AMENDMENTS TO THE DRAWINGS

REMARKS

FIG. 9

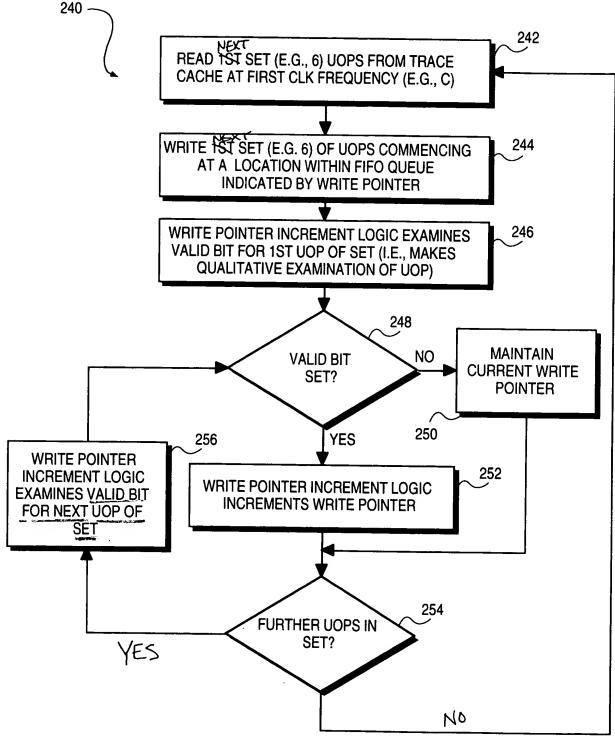
Applicants submit a replacement sheet and an annotated sheet of Figure 9 (appended hereto) for approval by the Examiner in accordance with MPEP § 608.02(v). The proposed replacement sheet is submitted to comply with the Examiner's request to label the paths emanating from block 254 and to clarify blocks 242 and 244.

The Examiner further objects to Figure 9 on the basis that Figure 9 and the specification disclose something different from the claims. In particular, the Examiner refers to "if the qualitative determination is to retain the first microinstruction, then advancing the write point ... if the qualitative determination is not to retain the first microinstruction, then maintain the write pointer" as recited in claims 1, 13, and 21. Applicants respectfully submit that on page 22 of the specification, in lines 11-21, it is described that the write pointer will proceed to the entry following the last valid microinstruction in that set. A new set of microinstructions will be written at the end of the previous set if the previous set contained a full compliment of valid instructions, or overwrite the invalid entries. Applicants respectfully submit that the description stated in the specification is consistent with the claim language and that which is depicted in Figure 9.

Figure 9 has been amended to include labels "YES" and "NO" for the paths emanating from block 254. Furthermore, Figure 9 has been amended to indicate "Read next set (e.g. 6) upos

from trace cache at first clk frequency (e.g., C)" at operation 242 and "Write next set (e.g. 6) upos commencing at a location within FIFO queue indicated by write pointer" at operation 244. These amendments are supported by the Applicants' specification as filed on page 22, lines 8-10.
